SUBJECT: Forwards responses ro Round One questions,Set 7 from Mechanical Engineering Branch.

Subject: WPPSS NUCLEAR PROJECT NO. 2
RESPONSES TO ROUND ONE QUESTIONS
SET 7 - MECHANICAL ENGINEERING BRANCH (MEB)

WPPSS NUCLEAR PROJECT NO. 2
RESPONSES TO ROUND ONE QUESTIONS
SET 7 - MECHANICAL ENGINEERING BRANCH (MEB)

WASHINGTON PUBLIC POWER SUPPLY SYSTEM NUCLEAR PROJECT NO. 2	MAIN STEAM RPV HEAD VENT ISOMETRIC	FIGURE 3.6-31a

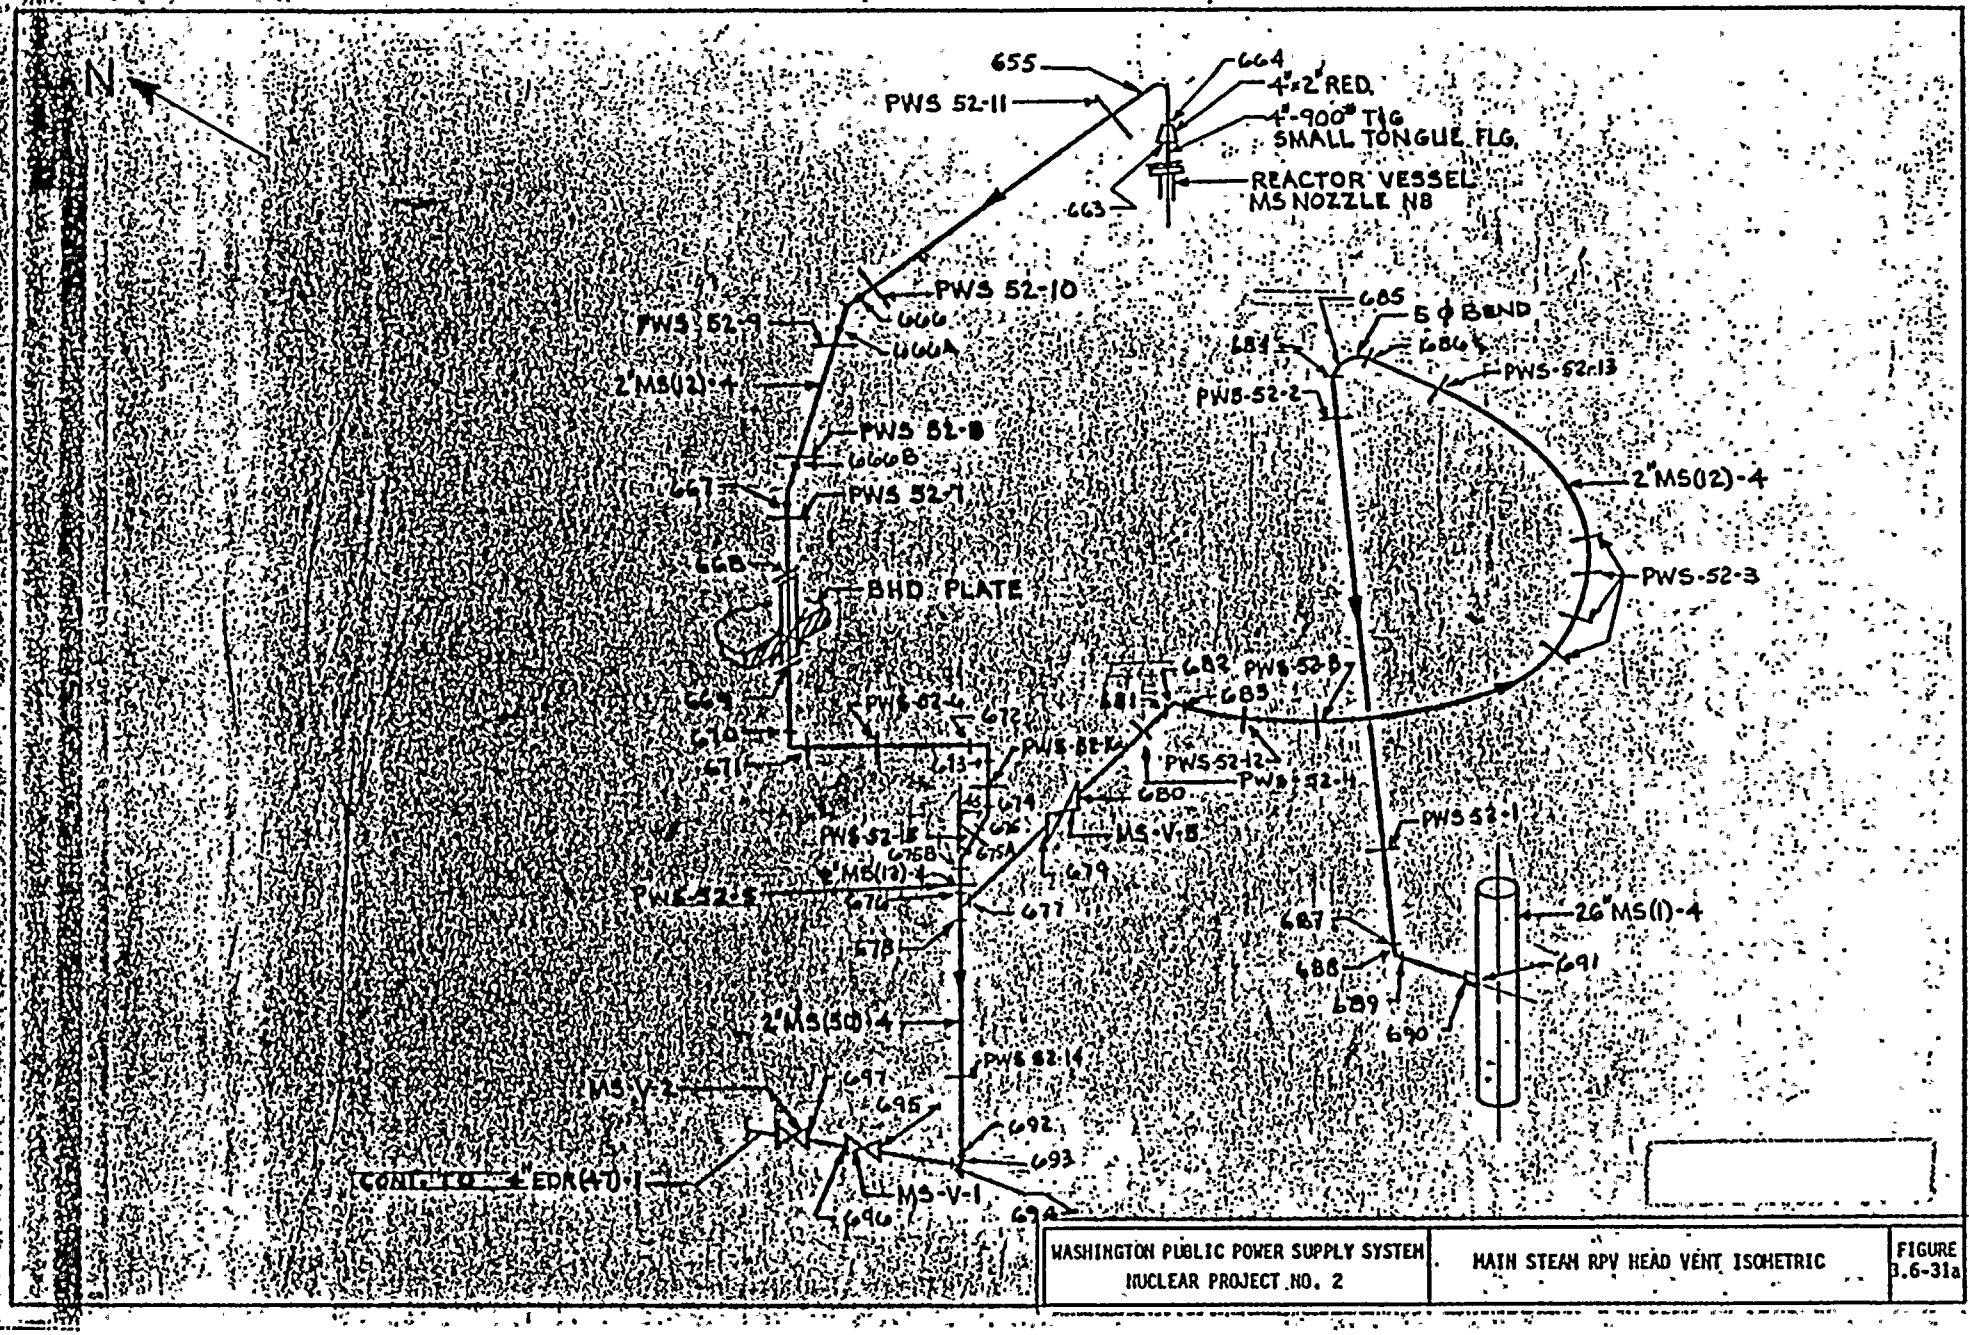
The postulated pipe breaks and pipe whip restraints for this system are shown in Figure 3.6-31a. For the piping section above the bulkhead plate, the pipe whip restraints are mounted onto a removeable lattice framework. For the portion of this line below the primary containment bulkhead plate, the restraints are mounted on structures, which tie into the stiffening beams for the bulkhead plate.

WASHINGTON PUBLIC POWER SUPPLY SYSTEM NUCLEAR PROJECT NO. 2	PIPE WHIP IMPACT ON TARGET	FIGURE 3.6-116

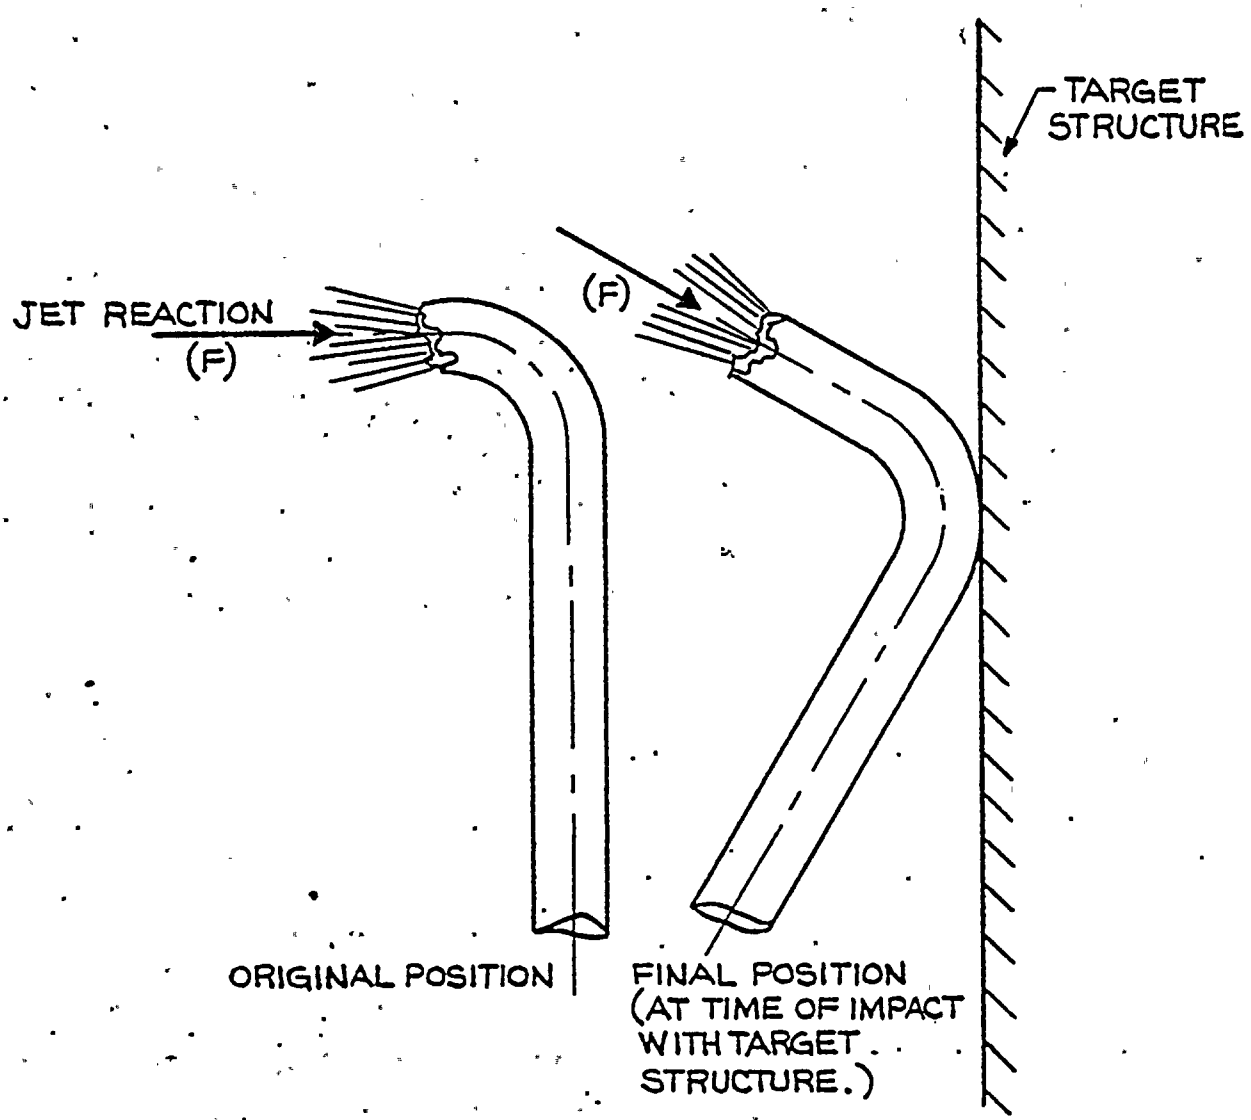
Pipe whip effects from circumferential breaks are illustrated in Figure 3.6-116. Jet impingement effects from circumferential breaks and longitudinal splits are illustrated in Figure 3.6-117. Circumferential breaks and longitudinal splits are defined in 3.6.2.1.4.

WASHINGTON PUBLIC POWER SUPPLY SYSTEM NUCLEAR PROJECT NO. 2	COEFFICIENTS FOR MOMENT OF INERTIA OF CRACKED SECTIONS	FIGURE 3.6-121

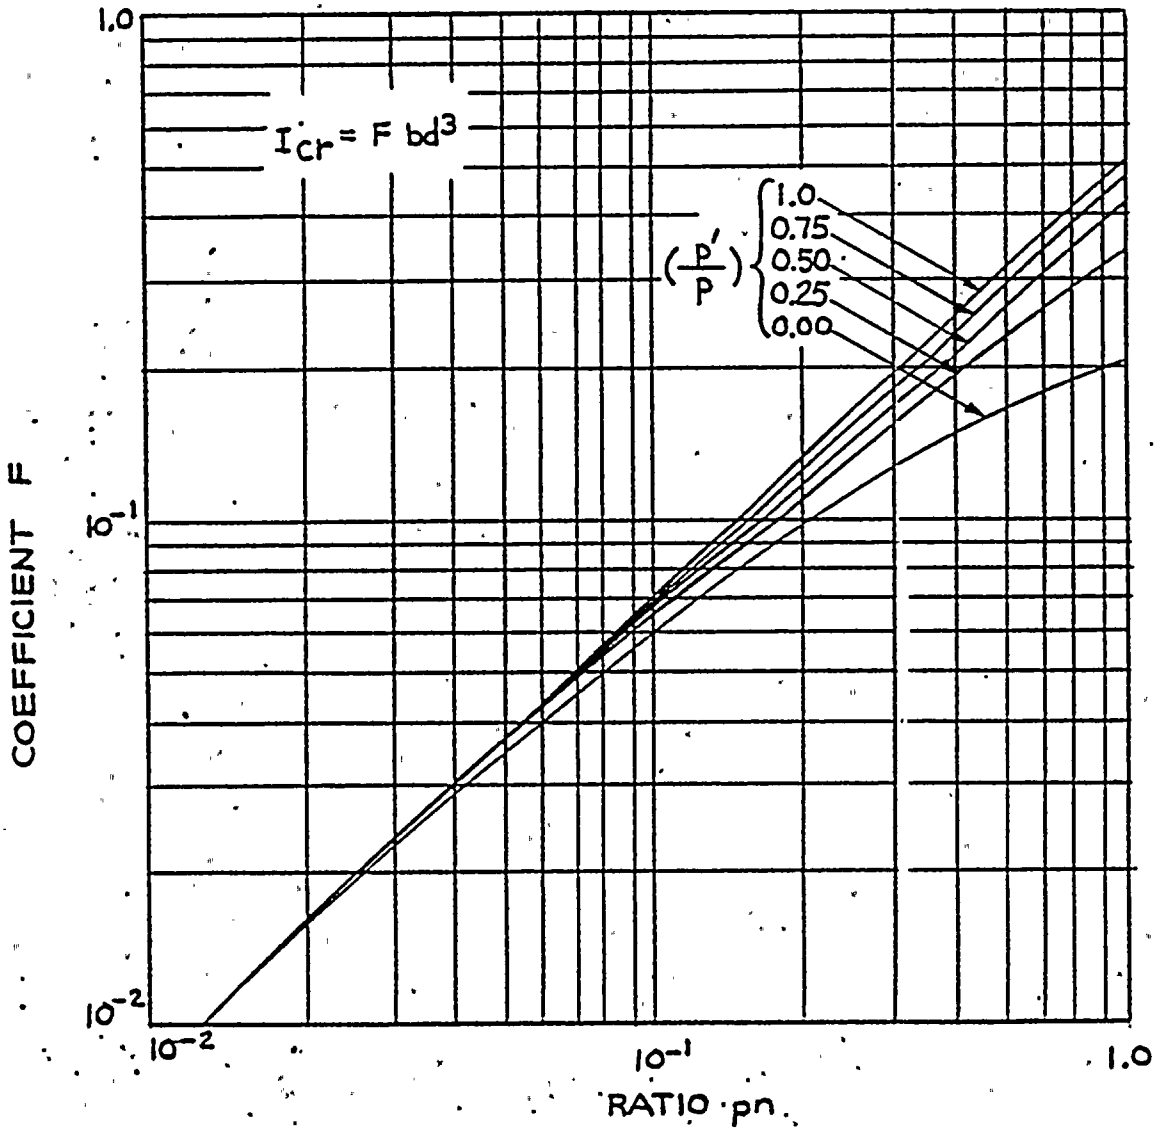
F = Coefficient for moment of inertia of cracked section with tension reinforcing only (see Figure 3.6-121)

WASHINGTON PUBLIC POWER SUPPLY SYSTEM NUCLEAR PROJECT NO. 2	DESIGN FOR WALL REBOUND	FIGURE 3.6-122

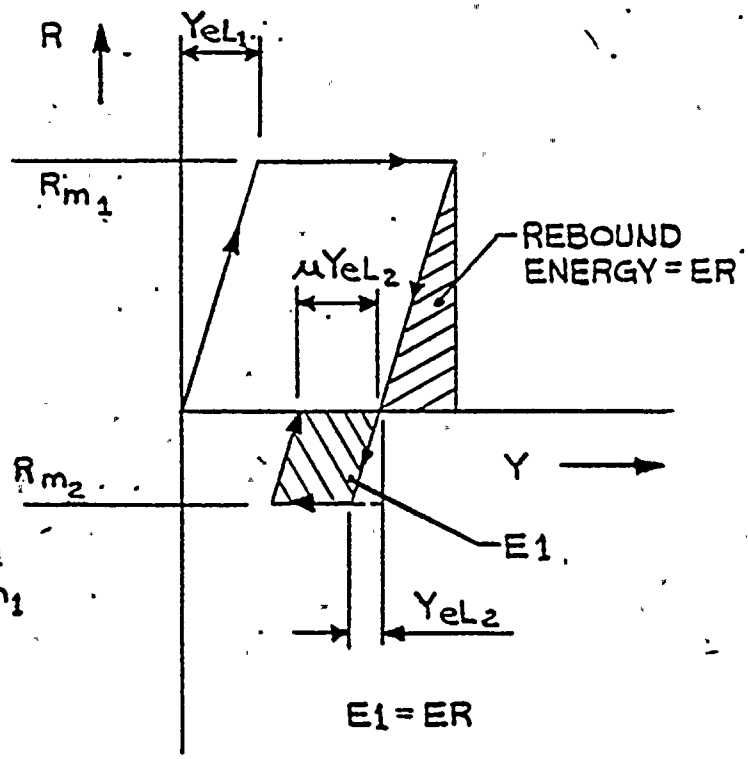
Structural elements such as floors, interior walls, exterior walls and the building as a whole are analyzed for the effects of reversal of load due to the postulated pipe failure accident. They are also analyzed for rebound loads that accompany pipe break accidents. The analysis approach for rebound is set forth in Figure 3.6-122.
